Addendum No. 1

City of Coquitlam

RFP No. 25-115

Town Centre Park - Park Services Hub Seacan Storage Containers

ADD: Figure 7

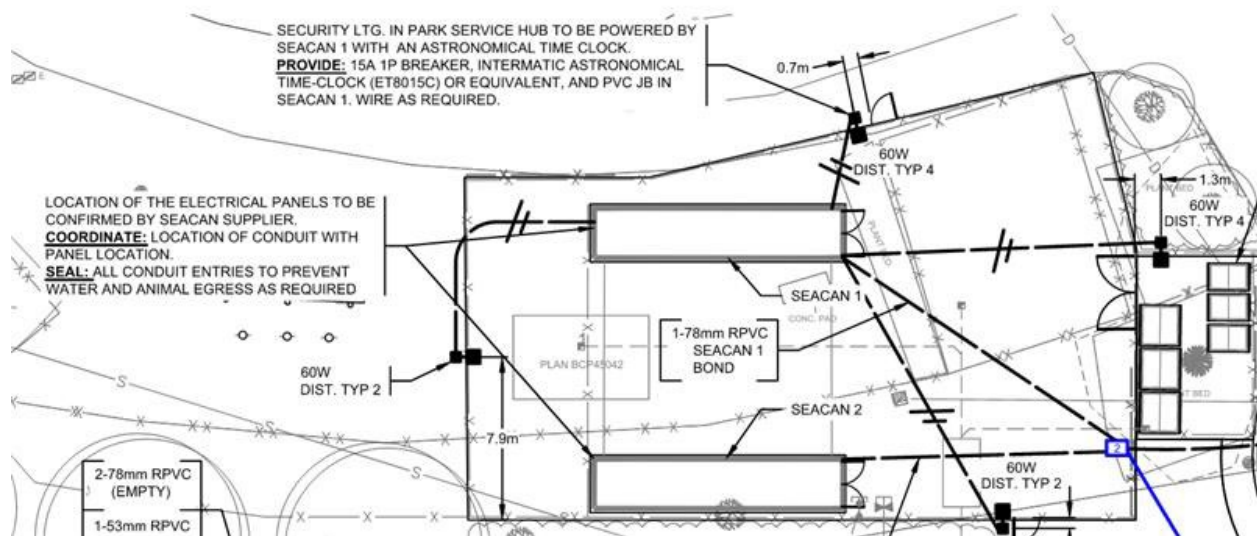
ADD: Security lighting in park service hub (4 fixtures) powered by Seacan 1 with an astronomical time clock/ 15A 1P breaker, astronomical time clock and PVC JB in Seacan 1 as described in Figure 7.
